Addendum #04

198th Readiness Center - Major Capital Improvements
Delaware Army Reserve National Guard (DEARNG)
New Castle, Delaware
Tt Project No.: 200-76984-16005
DEARNG Contract # 01-2016

Addendum No. 04
to
Drawings and Project Manual

May 17, 2016

Drawing No.:
M/SK-02

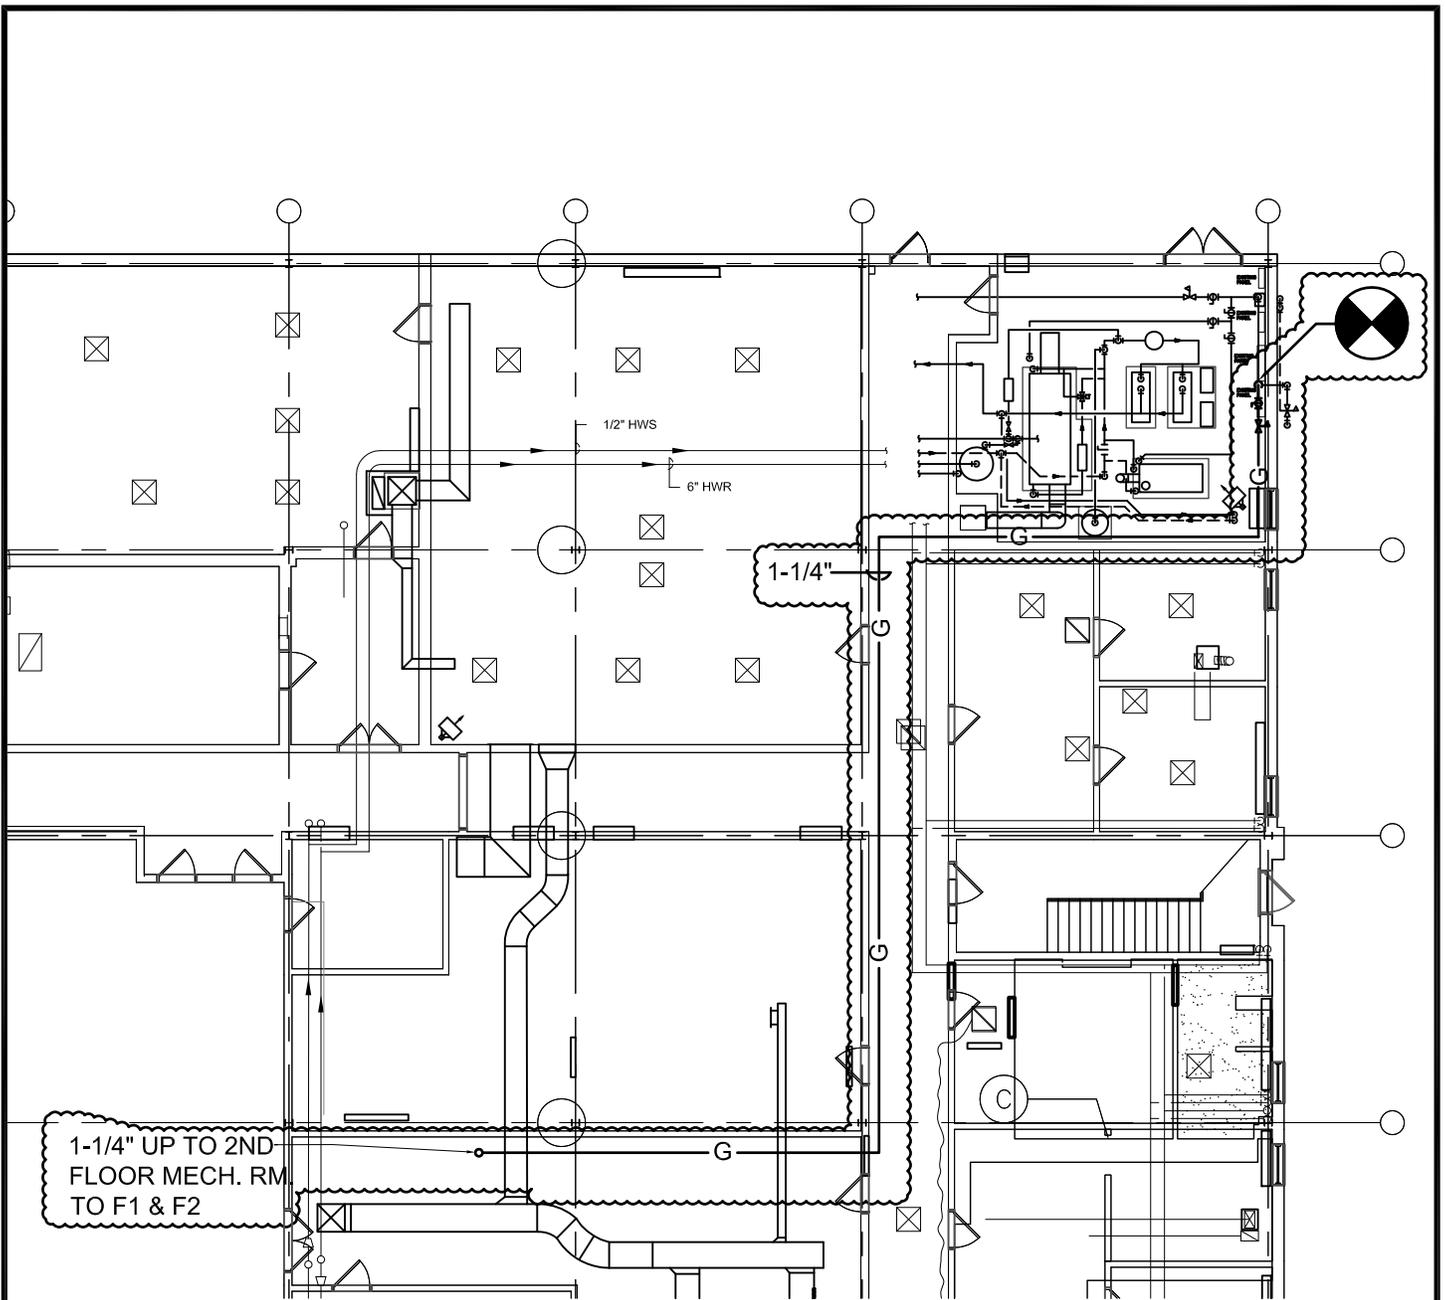
A. **ADD** Sketch M/SK-02 indicating the gas line requirements in its entirety to the project.

1. Question: F-1 and F-2 are gas fired. There are no gas lines shown on the drawings. Is there a gas line in the Mechanical Room?

Response: Yes, there is a gas line in the Mechanical Room that needs to be connected to. Refer to further direction in this addendum.
